SUBSURFACE WASTEWATER DISPOSAL SYSTEM APPLICATION

Subject: New System Variance Approval, Filled Land, Lee property, Stevens Road, Augusta

Subject: Replacement System Variance Request, Lee property, Stevens Road,
Augusta

SUBJECT: Approval Replacement System Variance Request, Orrin Lee Jr. property, Stevens Road, Augusta

SUBSURFACE WASTEWATER DISPOSAL PLAN

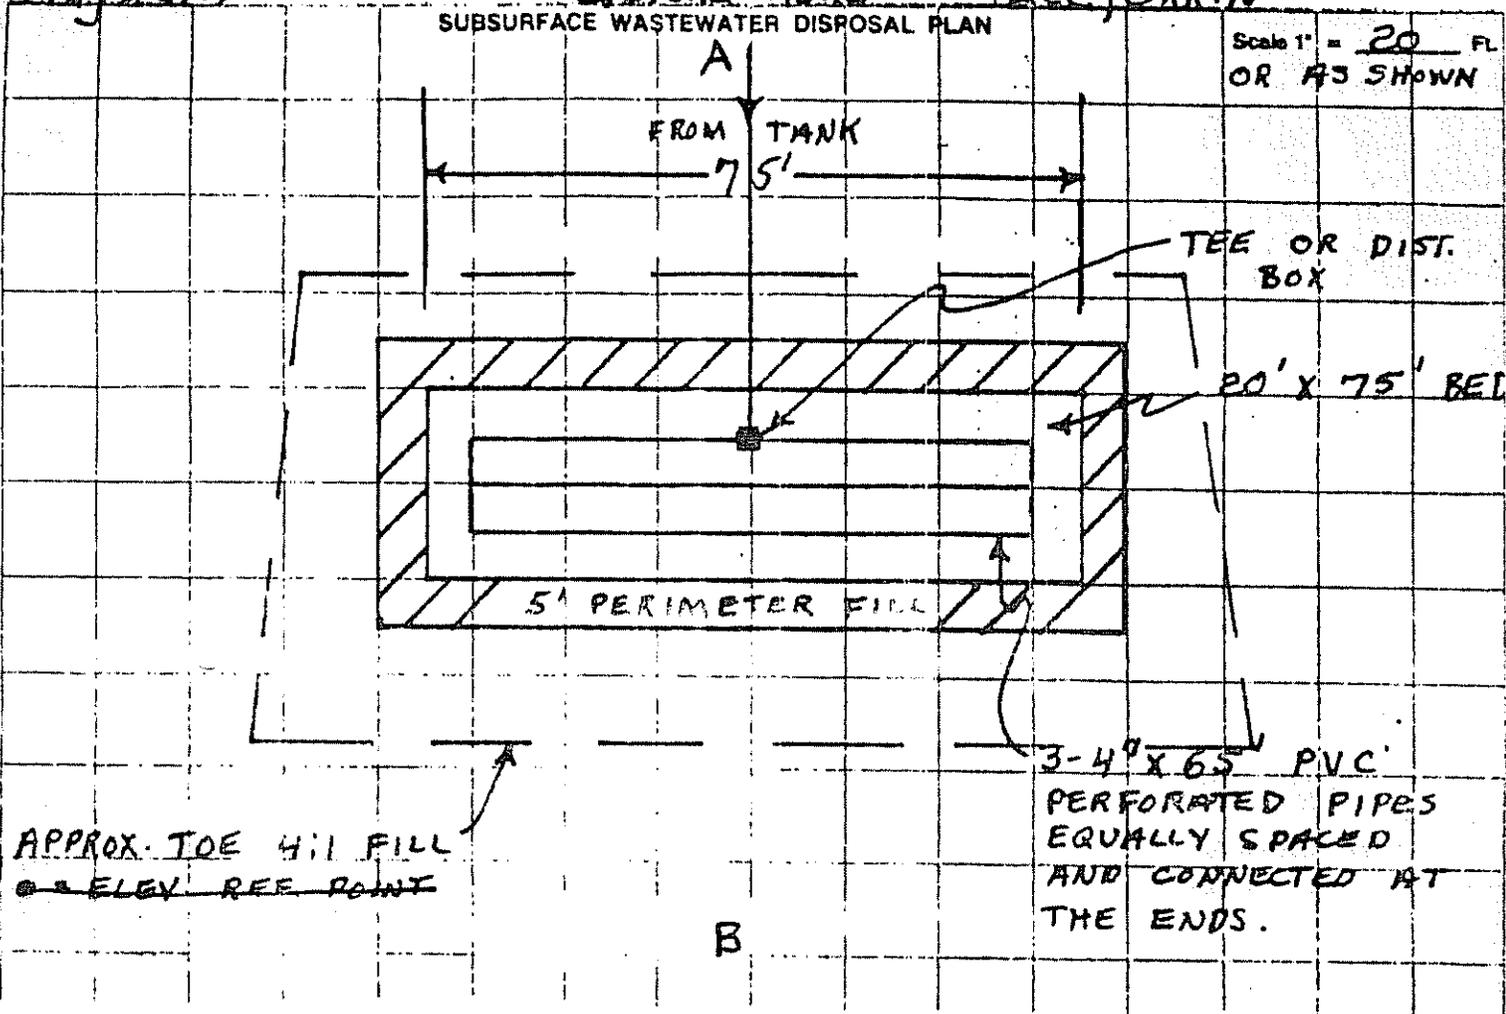
After review of the information submitted, this office is reluctant to recommend approval of the variance request. However, based on the age of the fill and the fact that a trailer is currently occupying the lot, this office will recommend approval provided the following conditions are followed:

- 1] The disposal system shall be increased from a 38 foot by 16 foot bed to a 56 foot by 16 foot bed or a 45 foot by 20 foot bed with a total of 900 square feet;
- 2] If the system malfunctions, the trailer shall be removed from the lot immediately;
- 3] The enclosed deed covenant shall be completed, recorded in the appropriate Registry of Deeds and a copy submitted to this office and the local plumbing inspector prior to issuance of the plumbing permit.

At least 15 inches and 28 inches of fill shall be applied on the uphill and downhill sides of the disposal field, respectively. The fill shall be of a texture similar to the original soil and will provide a 12 inch separation between the bottom of the disposal bed and the seasonal high water table and impervious layer. The fill must be extended in all directions as required by Section 11.D of the Subsurface Wastewater Disposal Regulations.

The installation of a 1000 gallon septic tank followed by a 56 foot by 16 foot or 45 foot by 20 foot bed system.
